**Project: IEEE P802.15 Working Group for Wireless Personal Area Networks
(WPANs)**

Submission Title: comment resolution assignment

Abstract: proposes comment resolutions for a set of CIDs

Figure 23: Two Part Preamble

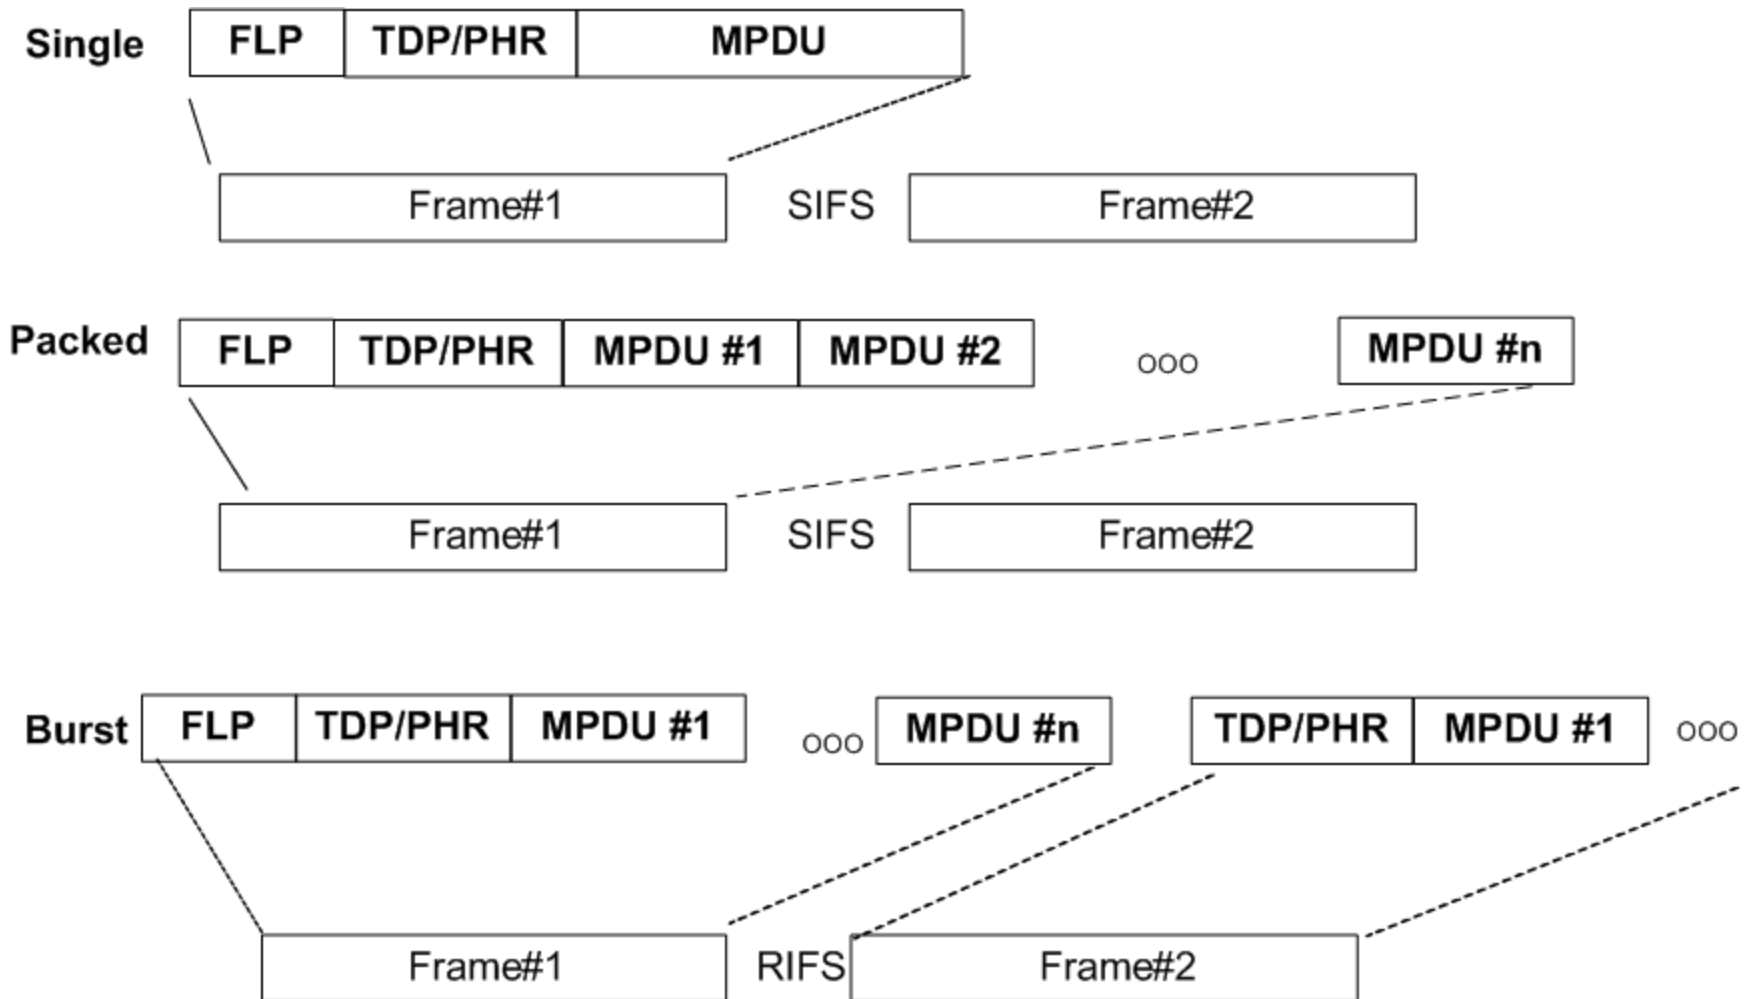
- In Figure 20, in Burst mode, there are two MAC PDU #n. These should be fixed.
- Figure 20 - Burst Mode - shows the same MAC PDU being transmitted twice, in both Frame #1 and #2. This figure does not align with the text
- (SY) In Burst mode, both packets are shown with the label "MAC PDU #n". I believe that the labels should be different

Instruction to editor: Update Figure 23

Update Page 39, line 40 as follows:

- The standard defines one fast locking pattern (FLP) followed by choice of 4 topology dependent preamble (TDP) repetitions for the purposes of distinguishing different PHY topologies.

Update Page 39, line 46 as follows:

- After the fast locking pattern, 4 repetitions of one of four TDPs are sent.
